**SUBDIVISION REVIEW SHEET****CASE NO.:** C8-2020-0021.0A**COMMISSION DATE:** April 27, 2021**SUBDIVISION NAME:** Fort Branch Subdivision**ADDRESS:** 5016 E. Martin Luther King Jr. Blvd.**APPLICANT:** Robert Penta**AGENT:** Jerome Perales (Perales Land Development LLC)**ZONING:** SF-3-NP (single family residence)**NEIGHBORHOOD PLAN:** MLK-183**AREA:** 2.9 acre (30,642 sf)**LOTS:** 6**COUNTY:** Travis**DISTRICT:** 1**WATERSHED:** Fort Branch**JURISDICTION:** Full Purpose**VARIANCES:** none**DEPARTMENT COMMENTS:**

CITY OF AUSTIN –DEVELOPMENT SERVICES DEPARTMENT  
SUBDIVISION APPLICATION – MASTER COMMENT REPORT

CASE NUMBER: C8-2020-0021.0A  
 REVISION #: 00  
 CASE MANAGER: Cesar Zavala

PROJECT NAME: Fort Branch Creek Subdivision  
 LOCATION: 5016 E MARTIN LUTHER KING JR BLVD

# FORT BRANCH CREEK SUBDIVISION

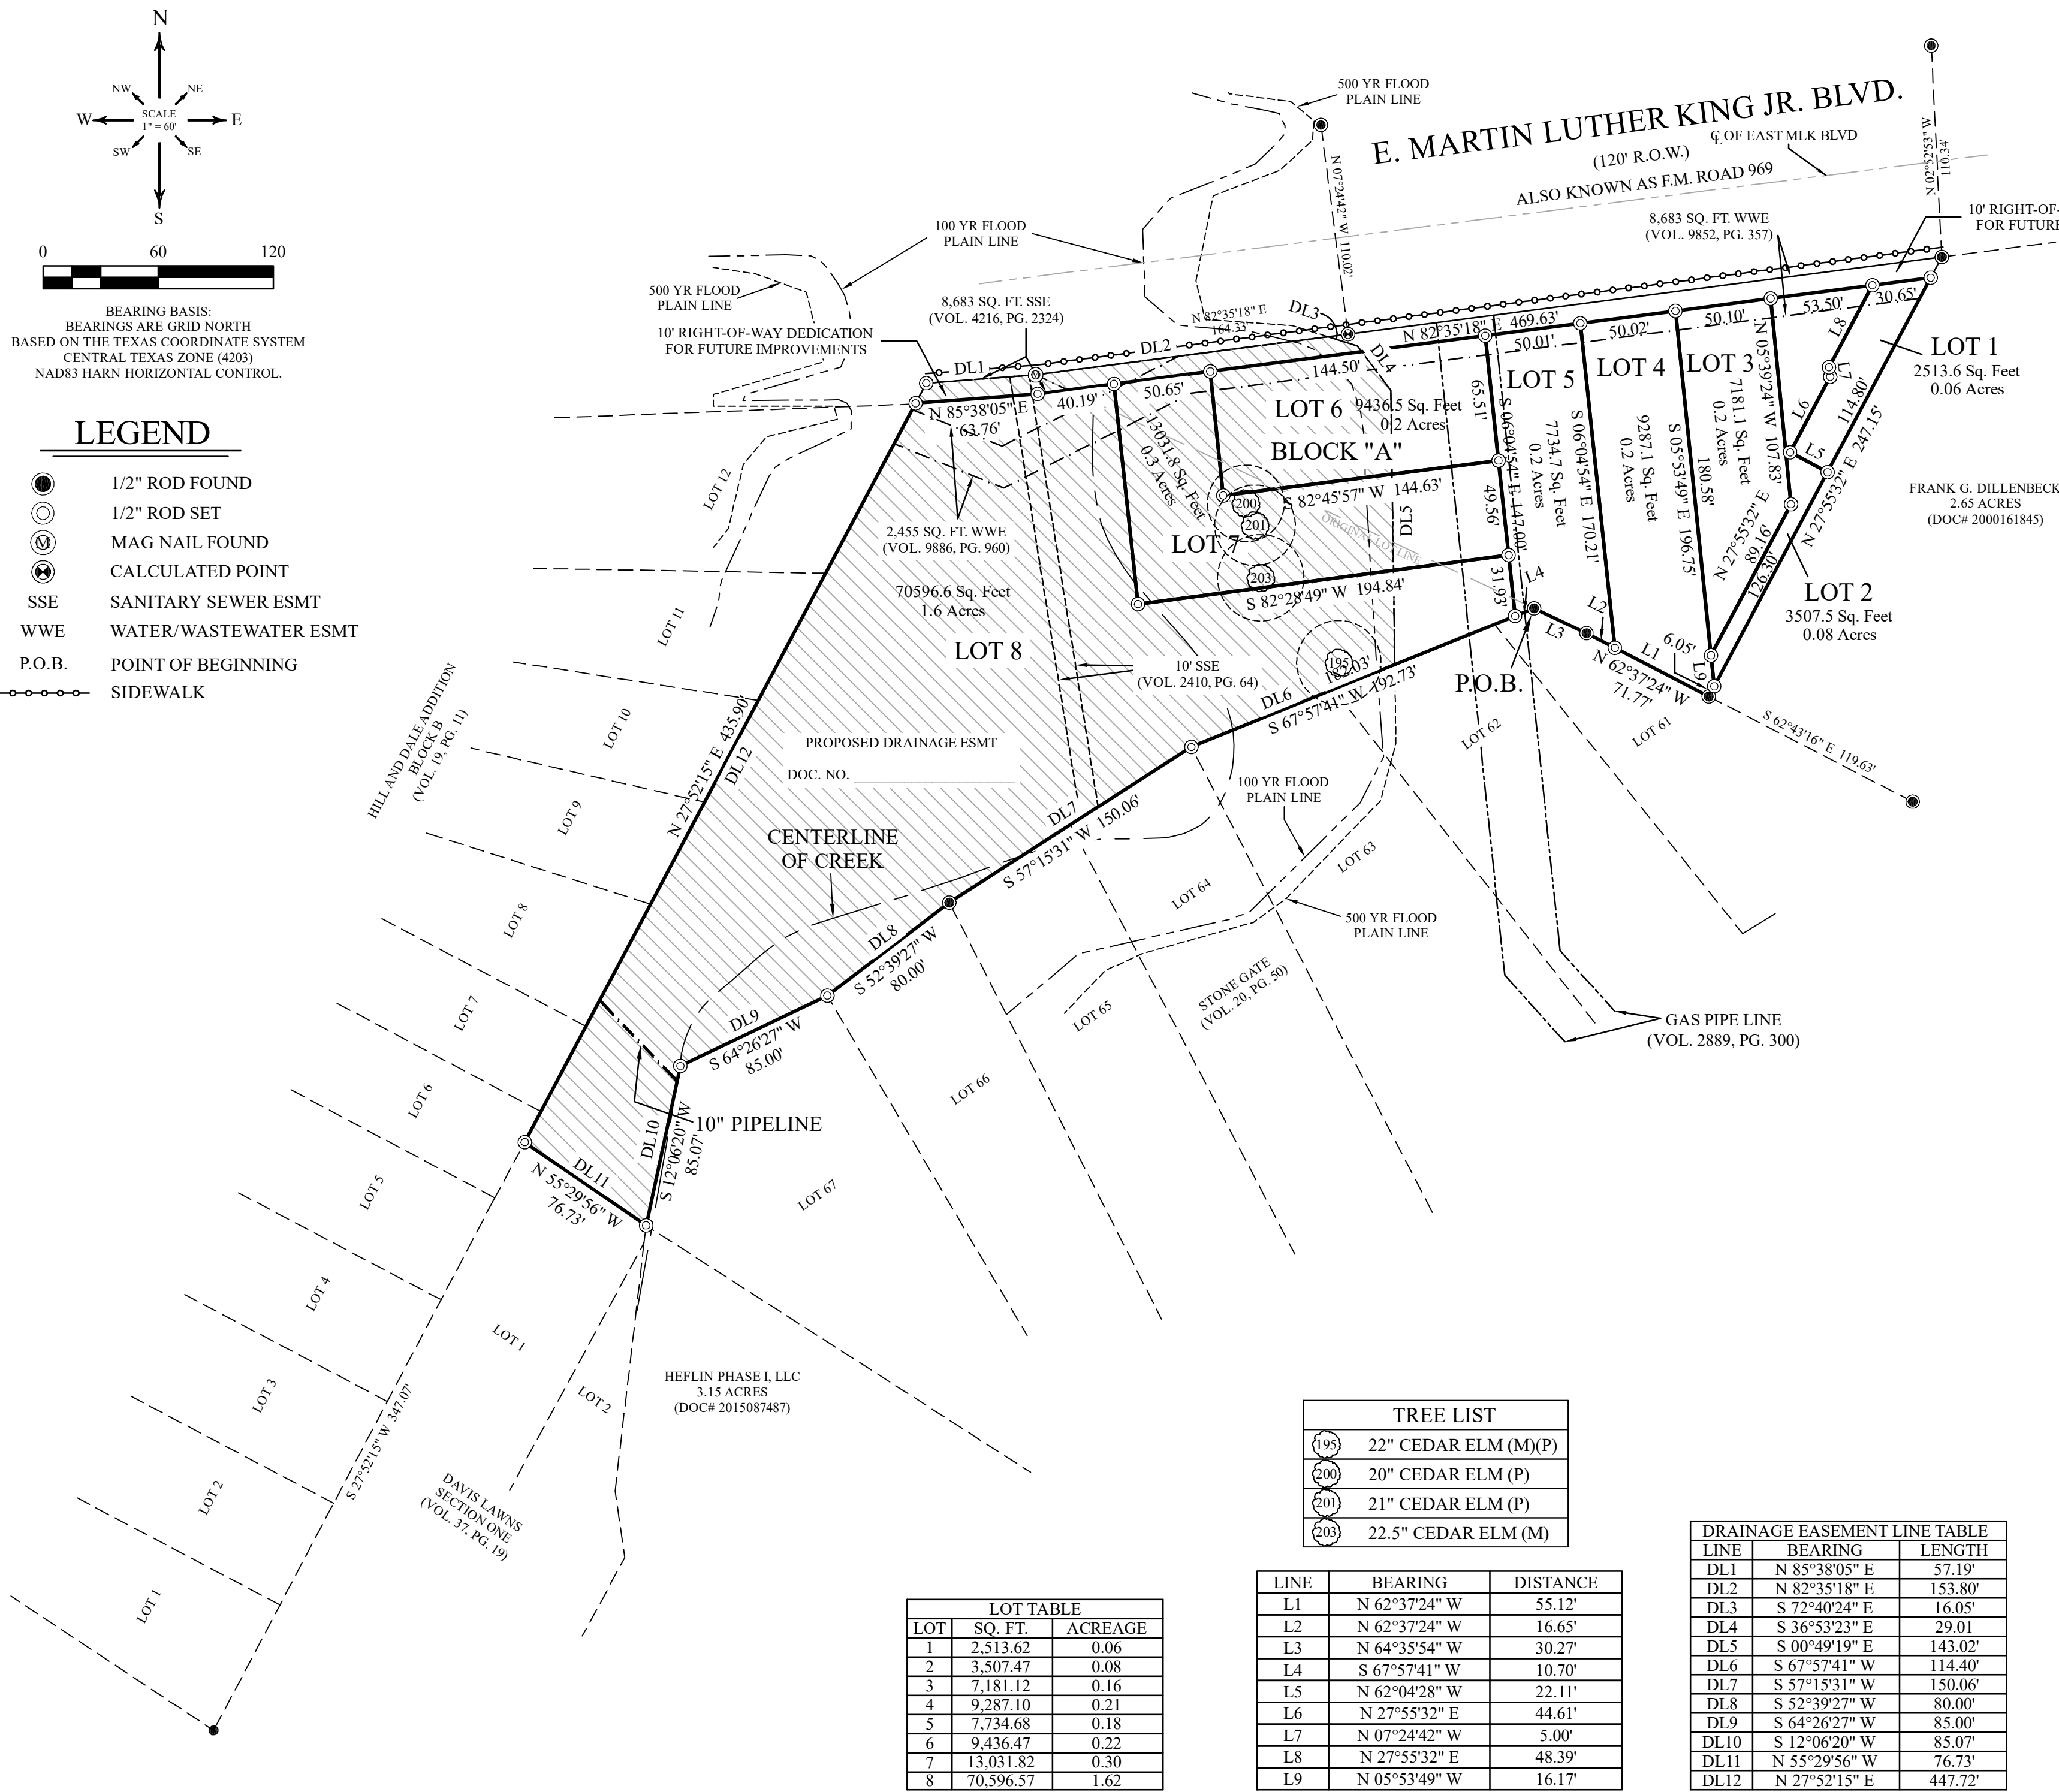
Fifteen foot electric distribution, electric telecommunications, and electric fiber easement is required adjacent to E MLK ROW. Show the easement on the face of the plat.

DE 1. Remove floodplain delineations from the plat in accordance with DCM 1.2.6.

DE 2. Provide confirmation from the floodplain reviewer that the fully developed 100 year floodplain will be contained within the drainage easement.

DE 4. The drainage easement for the floodplain is shown to be dedicated by separate instrument. Why are you not dedicating it with the plat? If not, the separate instrument document will need to be submitted for review.

DE 5. The subdivision drainage and water quality controls will need to be contained also in a drainage easement to be shown on the plat, with conveyance to the floodplain in a drainage easement.

- SR 1. Show all existing easements on the plat, annotate easements accordingly if provided by separate instruments. (L.D.C 25-1-83)
- SR 2. The plat is demonstrating a gas pipeline are, verify if the plat should comply with the Hazardous Pipeline section of the Land Development Code, Sections 25-4-134 and 25-2-516. If the pipeline meets the definition of a Hazardous Pipeline, the lots will need to comply with lot sizes as stated in 25-4-134(D) and other requirements as listed by code. A sign off or acknowledgement that the pipeline is not considered a Hazardous Pipeline will be needed from the Fire Department reviewer to clear this comment.

- SR 3. The property is zoned SF-3, minimum lots size for the zoning category is 5,750 square feet. Verify that the lots on the plat meet the zoning criteria. (L.D.C 25-1-83 / [25-2-492](#))

- SR 4. Lots should have a minimum width of 50 feet starting at the front building setback line ending 10 feet towards the rear of the lot. Verify that the lots meet the lot width requirement, as shown Lots 1, 2 and 6 do not meet the lot width requirement. L.D.C. [25-1-22\(C\)](#)

- SR 5. Remove the dashed lined annotating an original lot line. (L.D.C 25-1-83)
- SR 6. Show measurements for all lot lines on the plat.
- SR 7. Clarify if Lot 2 extends to East M.L.K between Lot 1 and Lot 3. If this is correct show a callout of the area between Lot 1 and Lot 3 showing that Lot 2 is part of the triangular area along the road to show frontage for the lot. Lots not having frontage to an existing roads require a commission approved variance to finalize a plat. L.D.C [25-4-171](#)

- SR 8. Add the lot totals on the Lot Table. (L.D.C 25-1-83)
- SR 9. The property description and survey notes can be removed from Sheet 1, this information is not needed on the plat for recording in Travis County.

Reference for comment #3

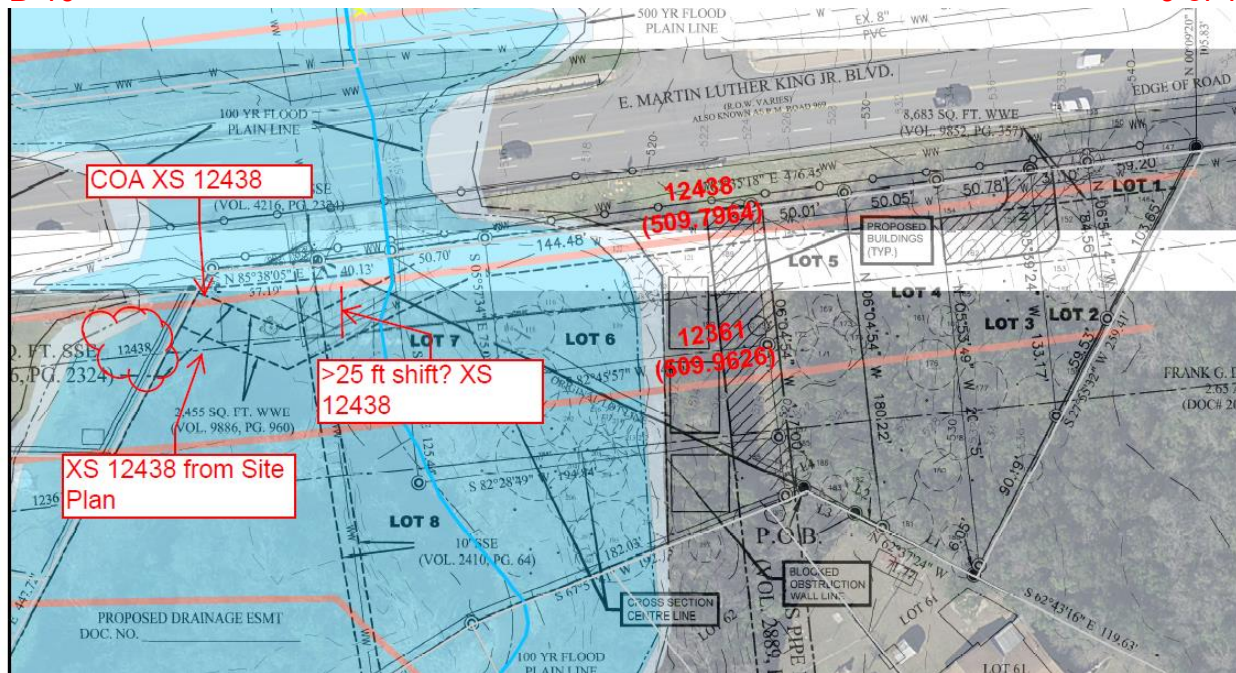
FP Reviewer Note: Doesn't seem to be proposed any development in the FP but need to be confirmed and verified with models and responses requested in this cycle of comment (particularly for comment #3). The requested clarification and responses for comment #3 may clear many of the other comments (comments # 4-6).

3. If the COA floodplain models were altered for this project, a project assessment is required. Looking at the submittals, it appears that FEMA 500- year floodplain is being used in place of Atlas 14 100-year and the floodplain/drainage easement is proposed to be dedicated accordingly. However, this cannot be confirmed and verified, since there seemed to be a shift in HEC-RAS cross sections in Exhibit 11 (please see the snip at the end of the FP comments below). Please double check the RS of those cross sections and other components of the models and explain the shift. It also helps to verify the delineation quickly if the applicant provides the shape files of HEC-RAS XS, 100-yr and 500-yr FP, and the Georeferenced site plan image used to plot in the plan sheets and exhibits.
